PLAN OF LAND
IN
NEWBURYPORT, MA
SHOWING
PROPOSED SITE IMPROVEMENTS
AT
2-6 MARKET STREET
(MAP 47 - LOT 59)

Subject: 2-6 Market Street Response to Engineering Review Comments

In response to design review comments provided by Phil Christiansen and Jon-Eric White, we have prepared the following responses. Please note these address outstanding issues. All previously addressed issues are not included.

GRADING PLAN
SHEET: C-3

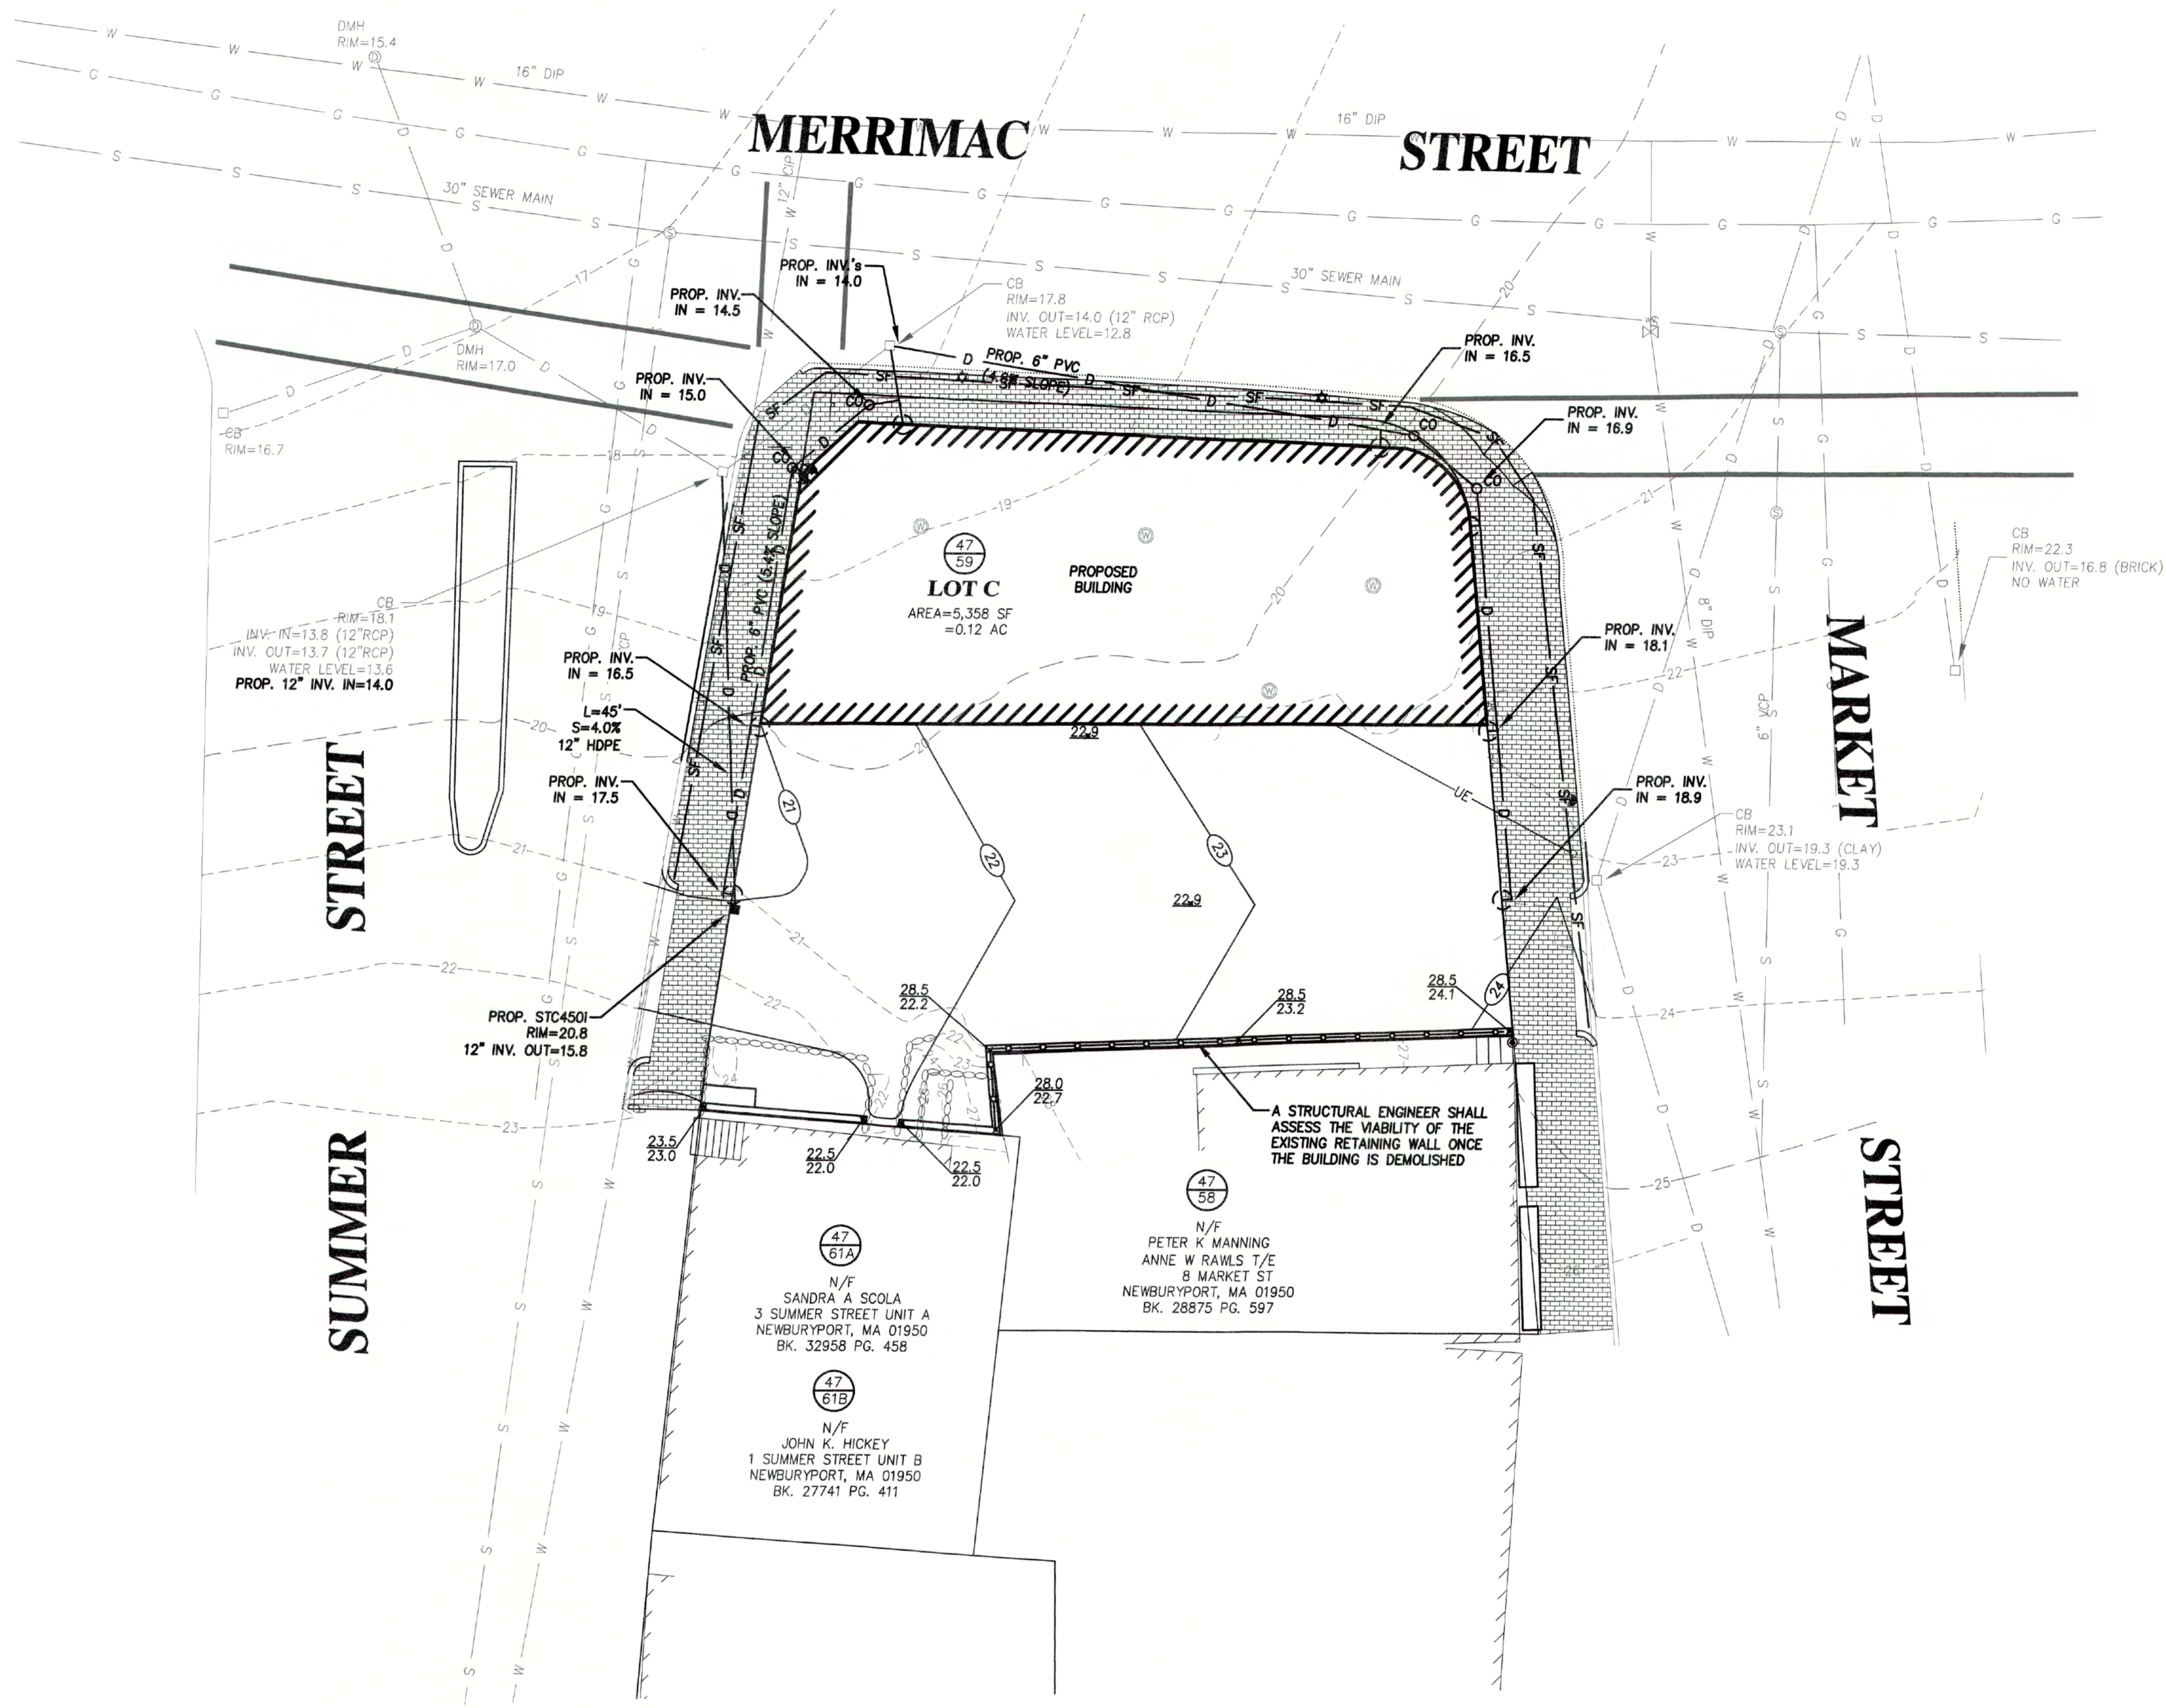
The wall elevations are on the Grading Plan not the Site Plan.

The downspout locations are shown but the invert elevations are not.

Response: We typically show retaining wall grades on the grading plan only.

Response: Inverts have been added to plans (see sheet C-3).

TURNING MOVEMENTS

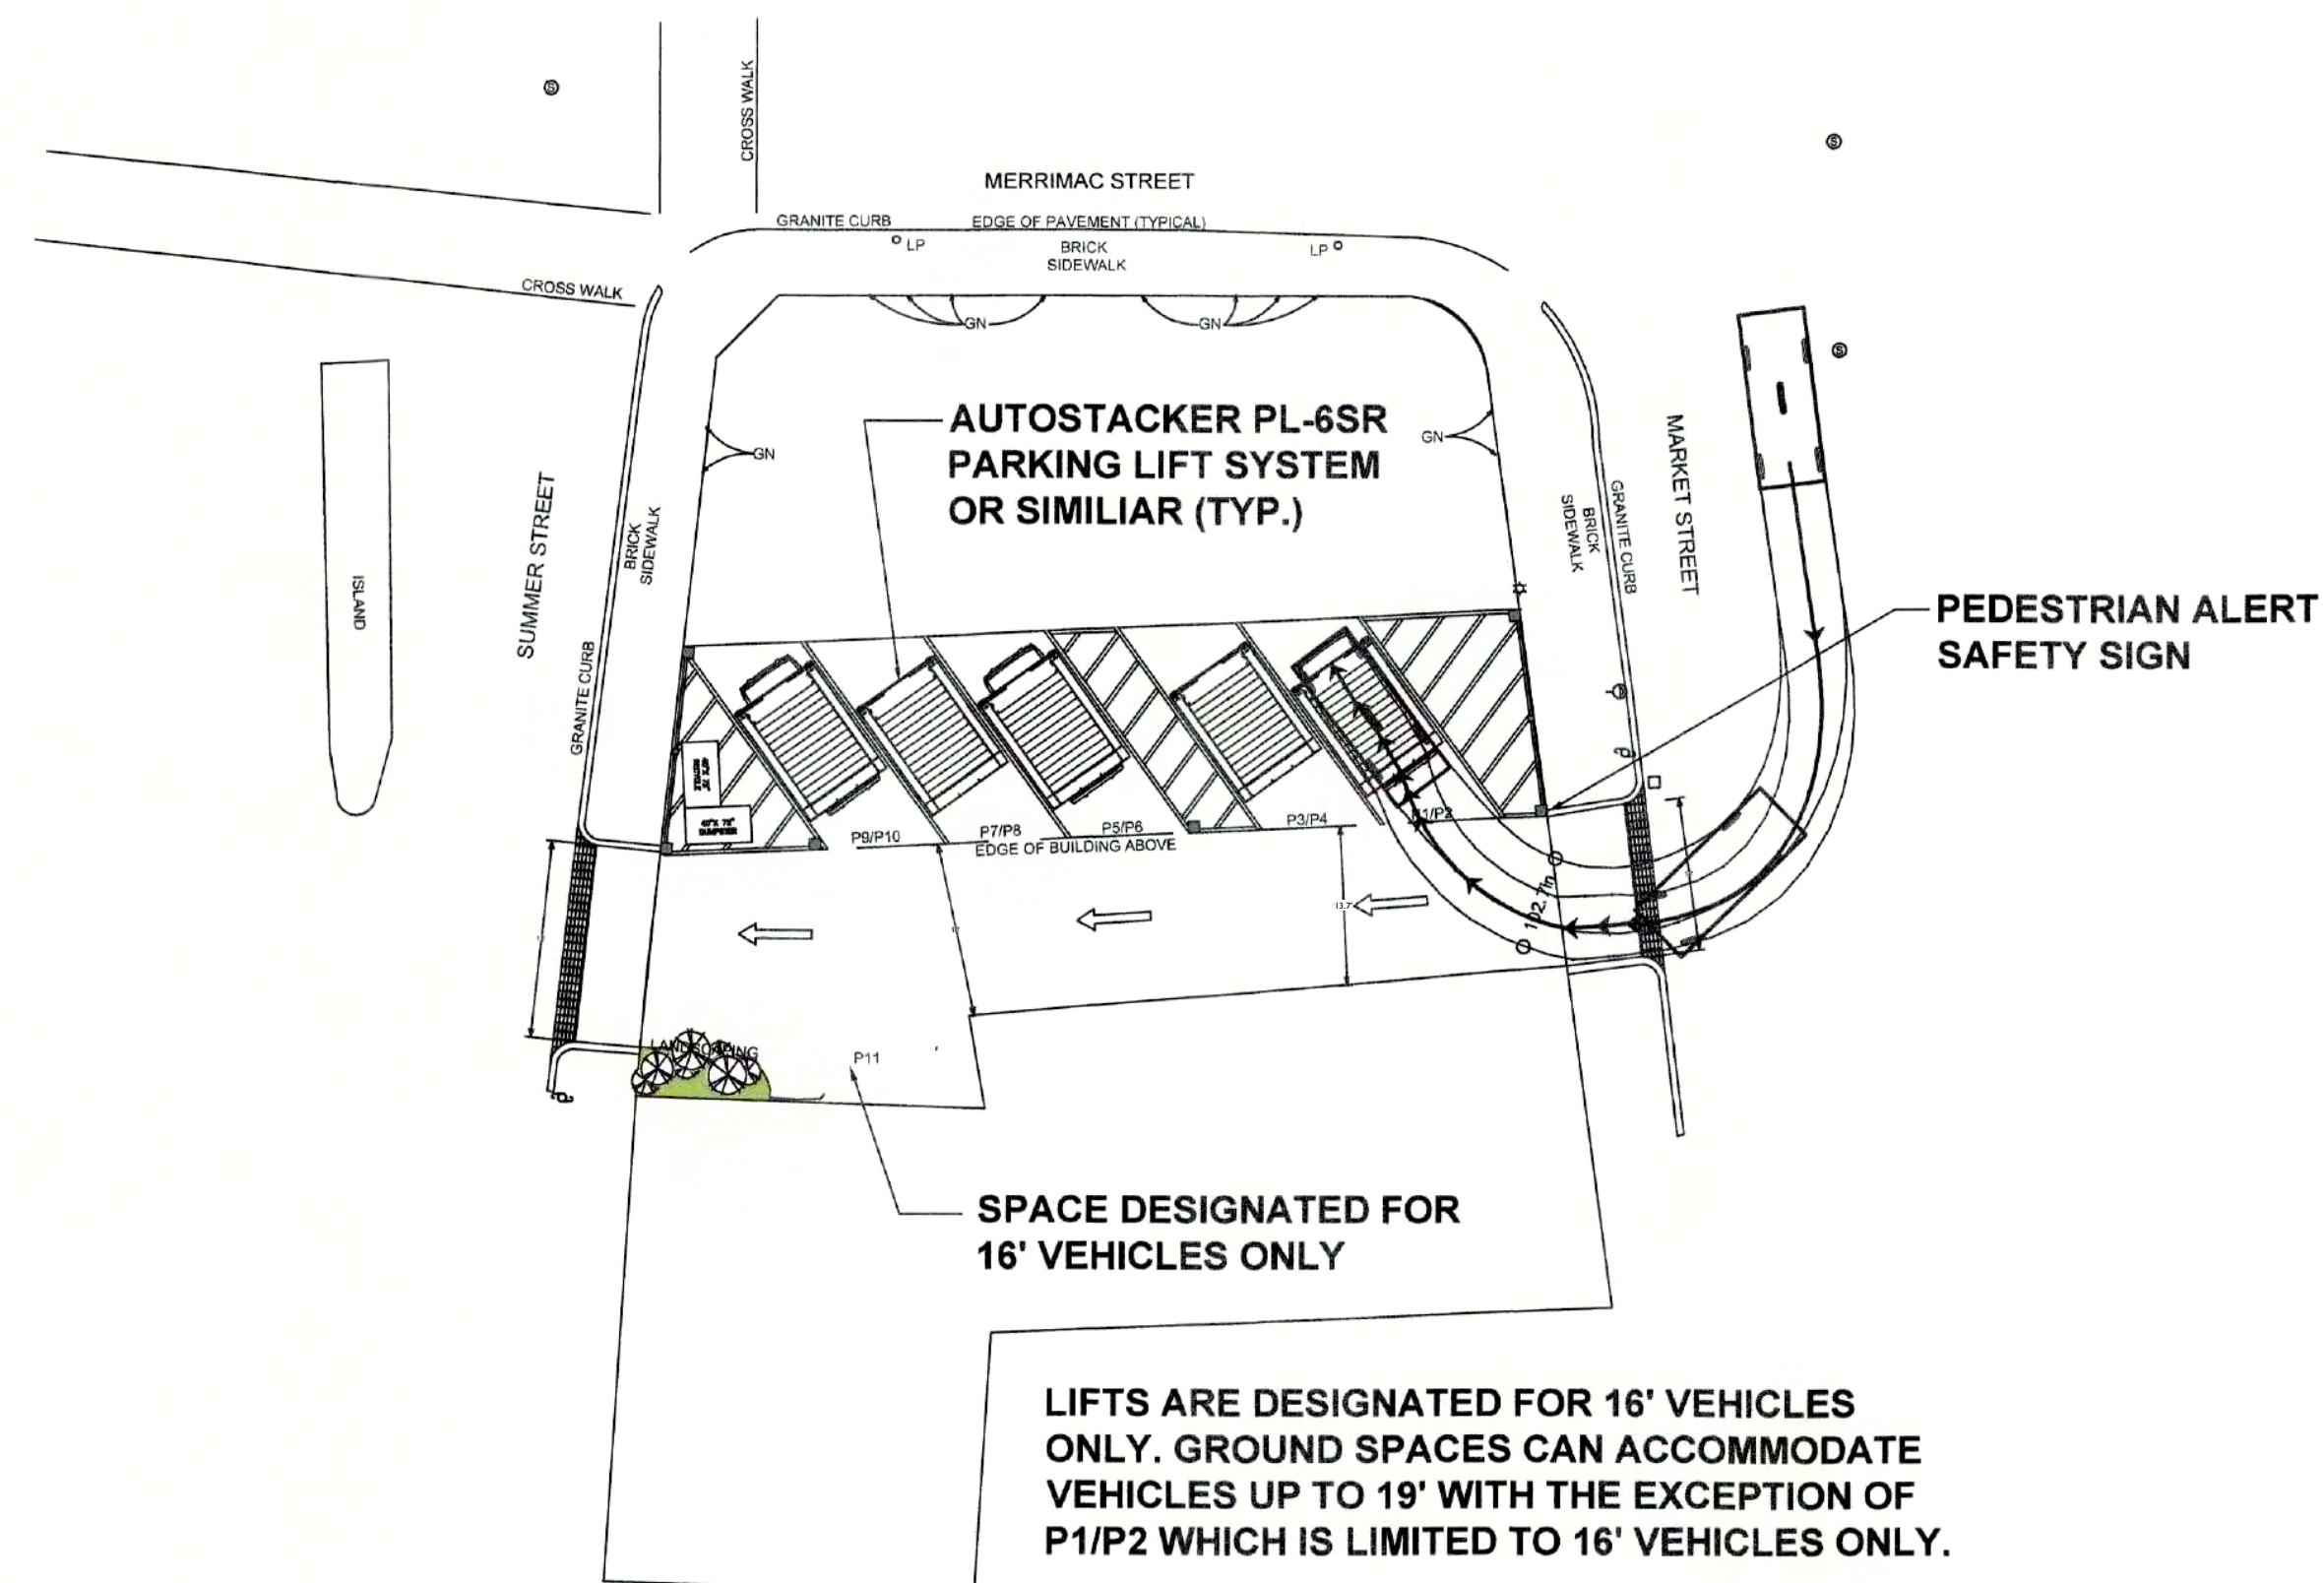
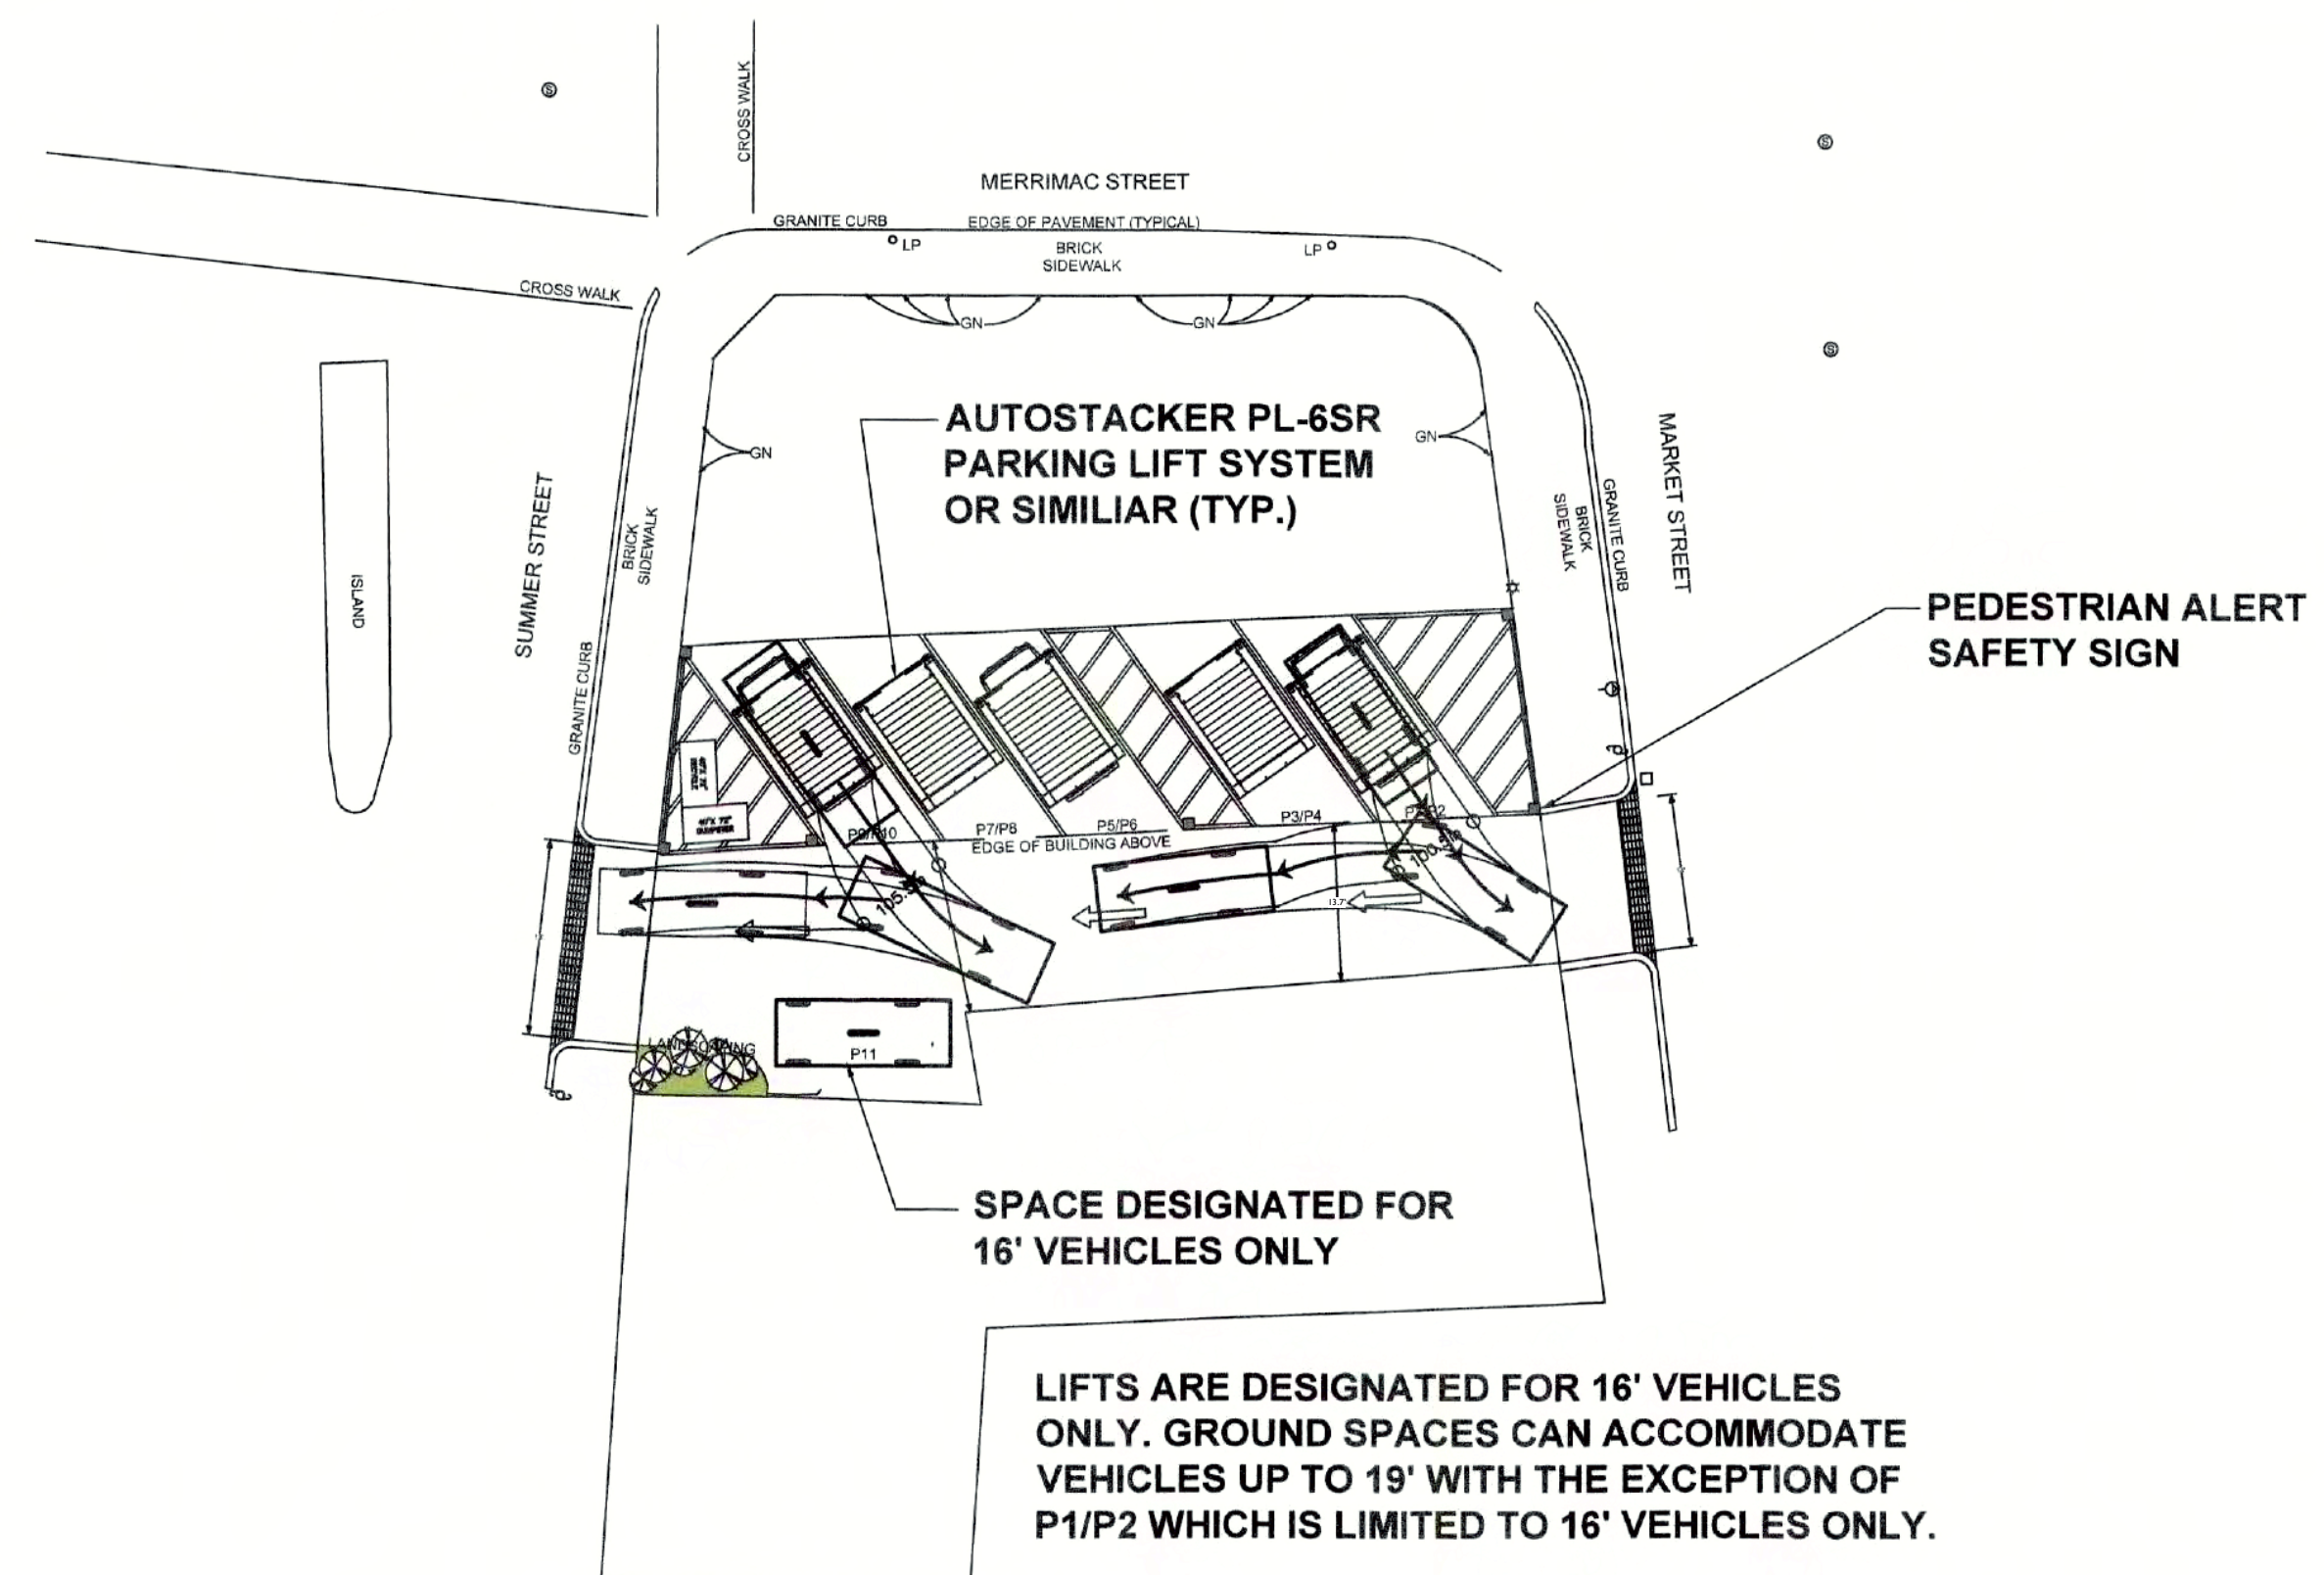
The limited isle width coupled with the use of the Autostscker PL-6SR Parking Lift Platforms make entering and exiting P1/P2 and possibly P3/P4 problematic. The platform width is approximately seven feet. An individual would have to back out straight until the front wheels were clear of the raised metal on each side of the platform. See attached pdf with a car shown in blue. Vanasse should provide turning movement diagrams for vehicles entering and exiting P1 and P3 using the proper aisle width and specifying the type or size of car used.

Response: 2 parking spaces have been eliminated and the parking layout has been revised. Vanasse has provided turning templates for the revised parking layout.
